Westinghouse  
Electric Corporation

NTD-NRC-94-4276  
DCP/NRC0195  
Docket No.: STN-52-003

SUBJECT: WESTINGHOUSE RESPONSES TO NRC REQUESTS FOR ADDITIONAL  
INFORMATION ON THE AP600

NTD-NRC-94-4276  
ATTACHMENT A  
AP600 RAI RESPONSES  
SUBMITTED AUGUST 26, 1994

Figure 230.79-1  
2D SASSI Analysis, E-W Direction  
Soil Degradation Curve Evaluation

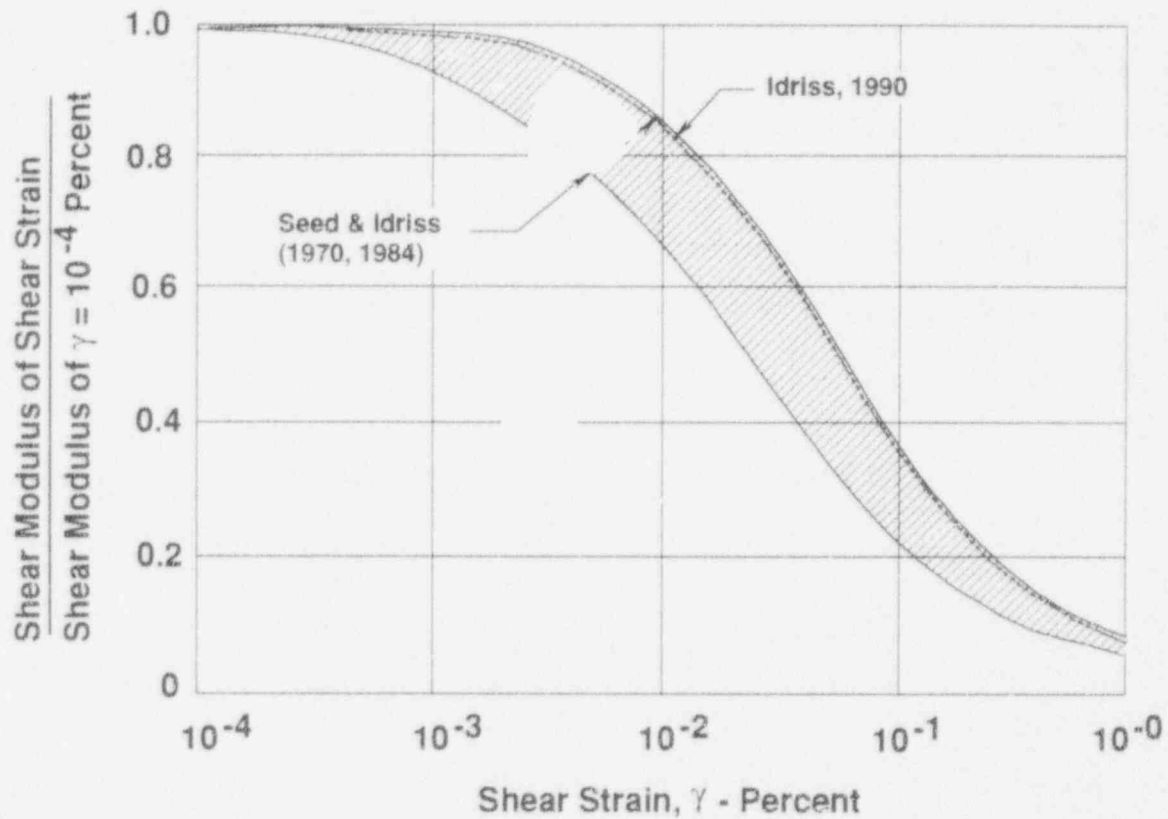
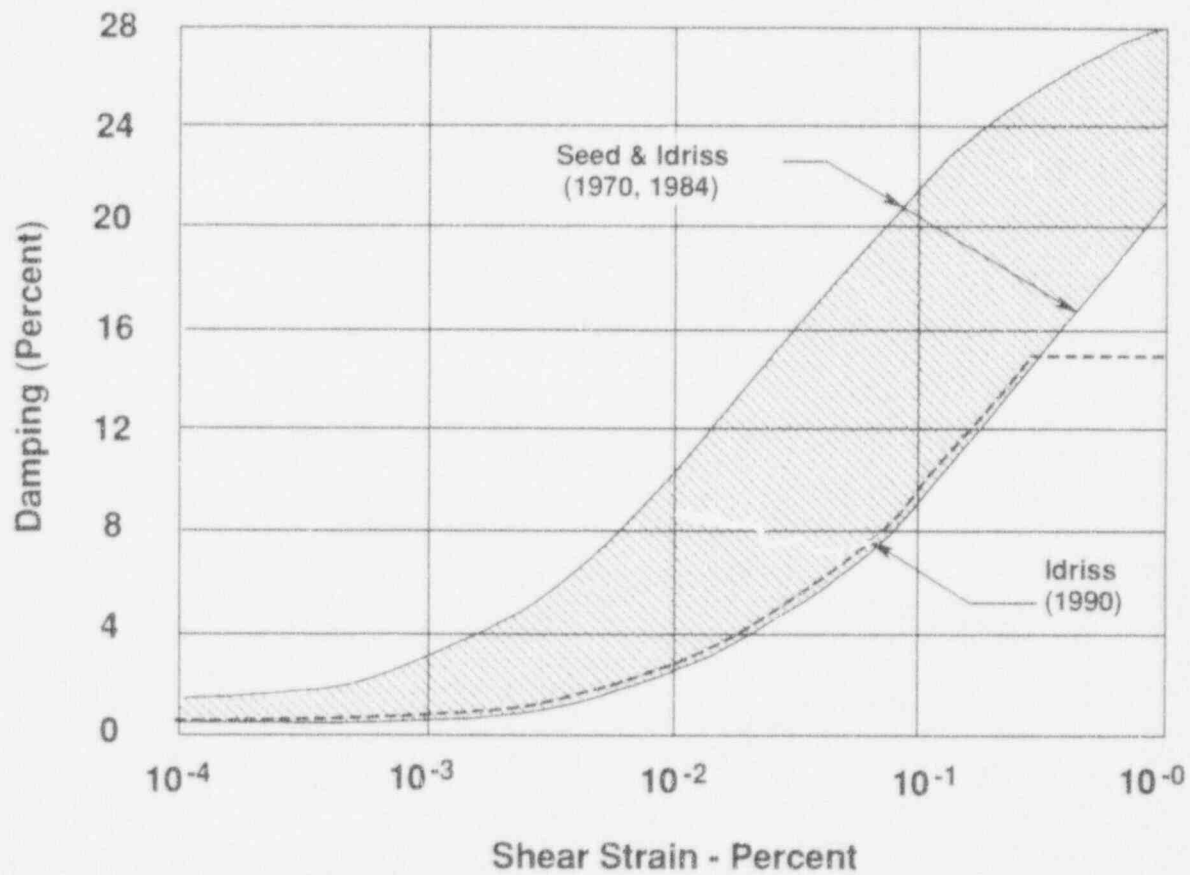
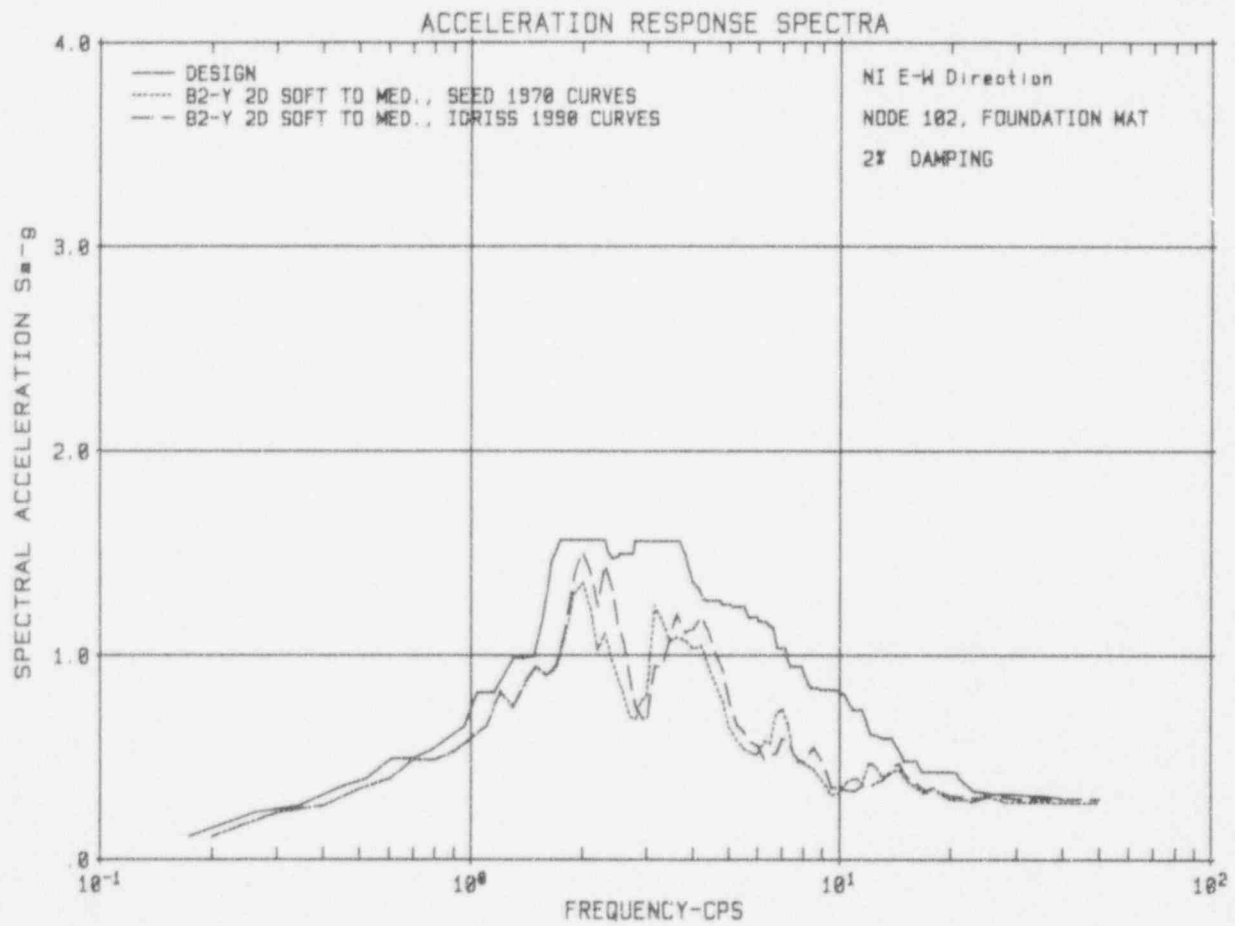
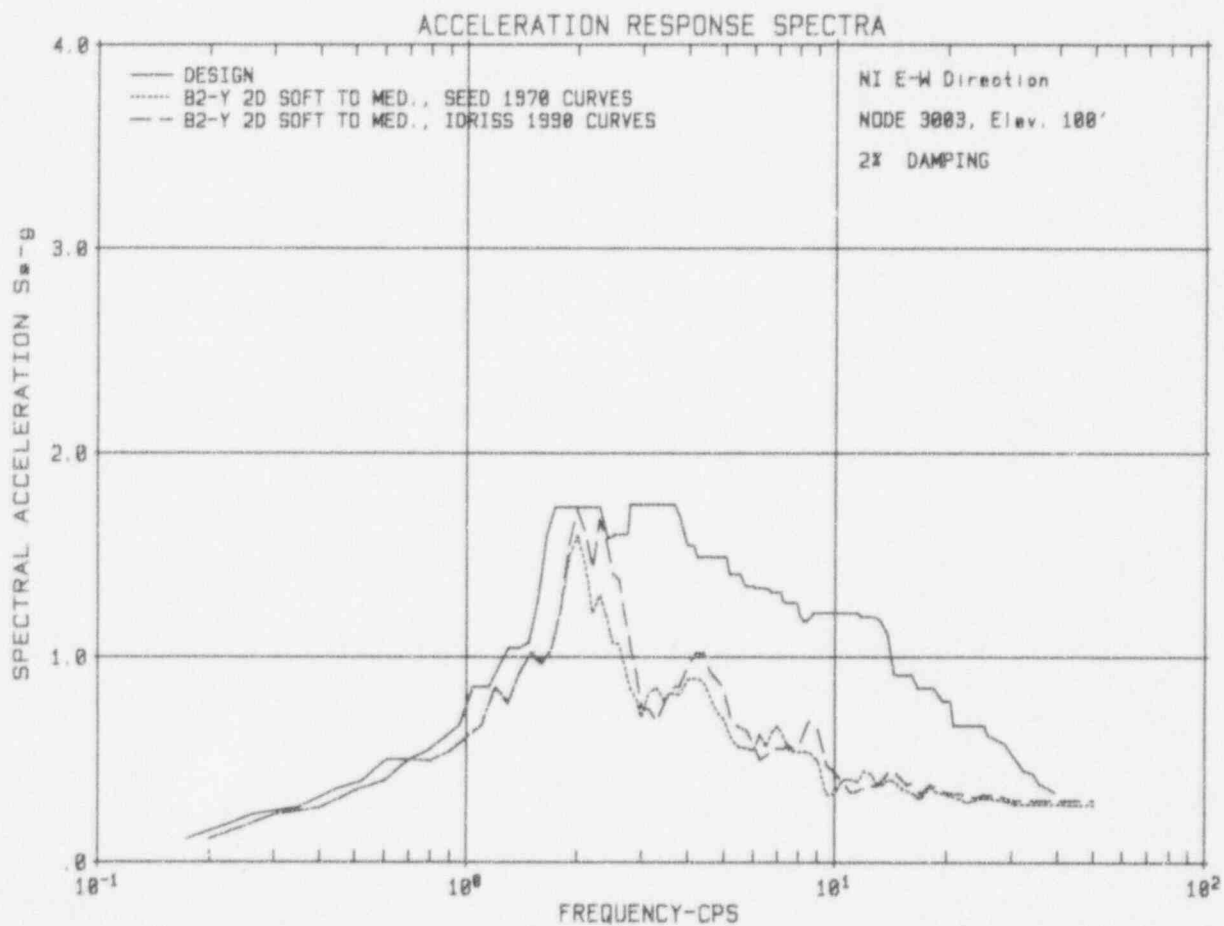
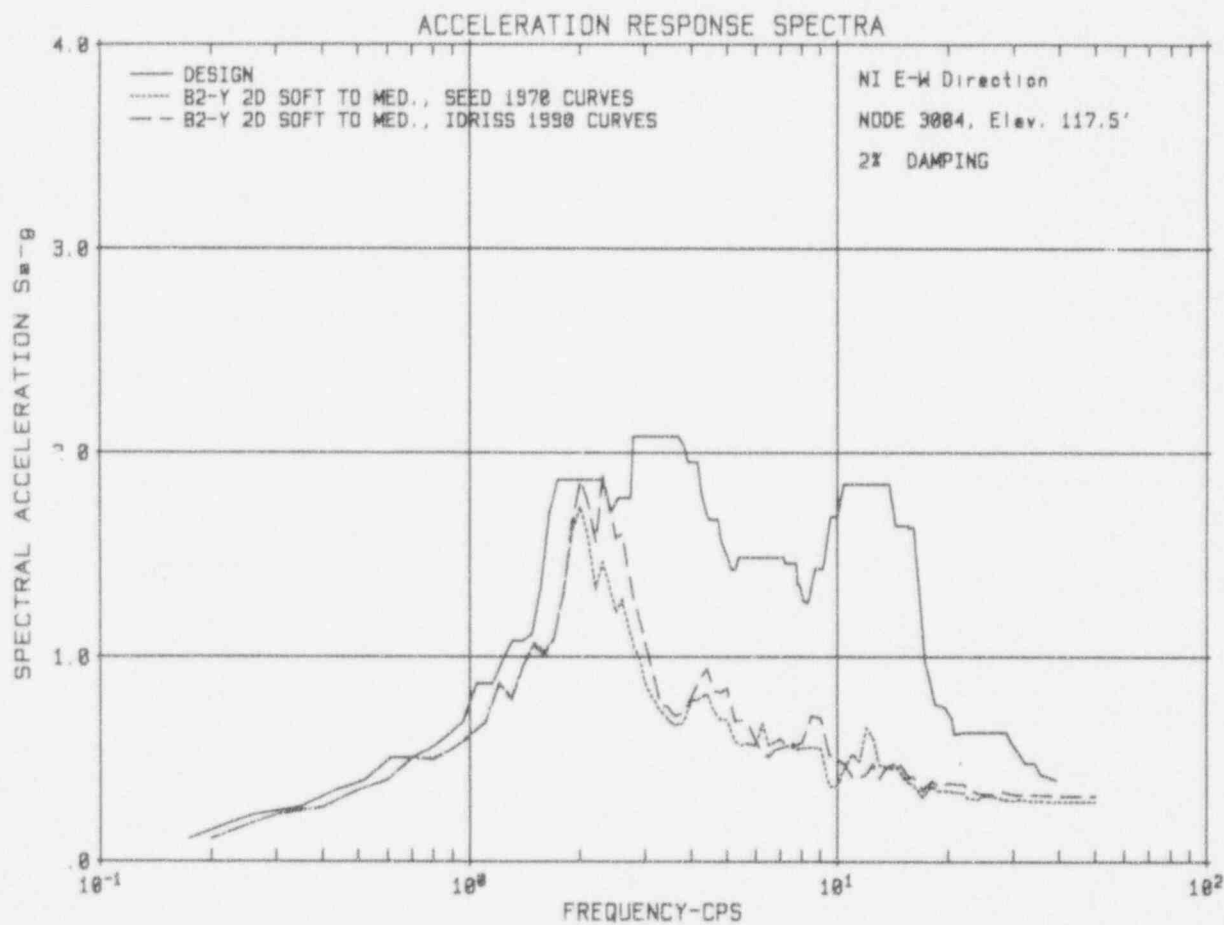
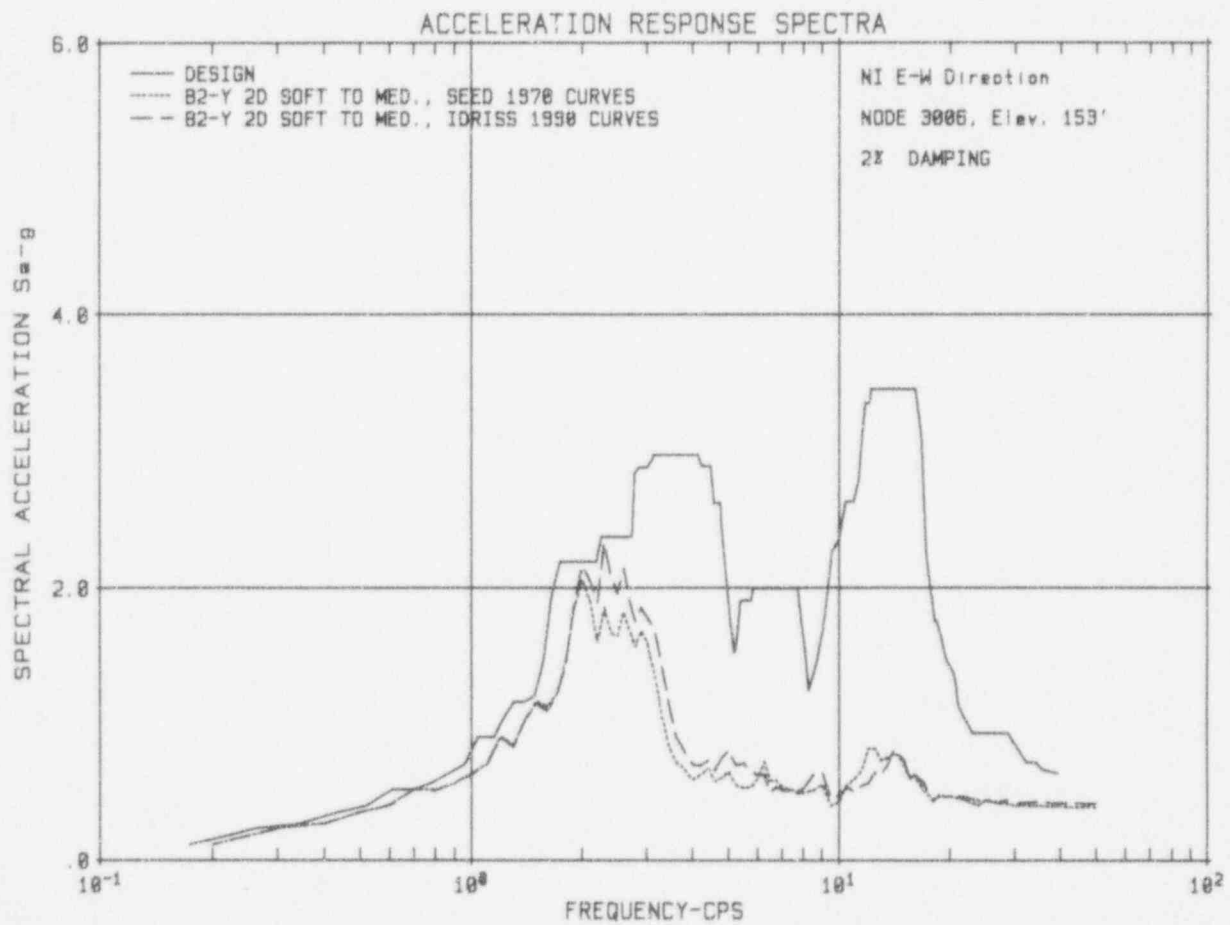
#### Question 230.79

In relation to the above RAI, a concern was raised by the NRC team during the July 1994 audit regarding the adequacy of the range of soil degradation curves for sites with clay contents. In order to address this concern, the site-specific soil degradation curves for the Savannah River Site (marked as Geomatrix and Bechtel) and the Lotung site are compared with the range of Seed & Idriss curves in Figures 230.79-14 and 230.79-15. The soil materials at these two sites can be characterized as silty sand and clayey sand. As can be observed from these figures, the range in Seed & Idriss' study adequately covers the soil degradation curves of these sites. On the other hand, the strain-dependent properties of pure clay materials with high plasticity fall above the range in Seed & Idriss' study. However, sites with pure high plastic clay would not meet the AP600 interface requirements for minimum shear wave velocity characteristics and for bearing capacity.
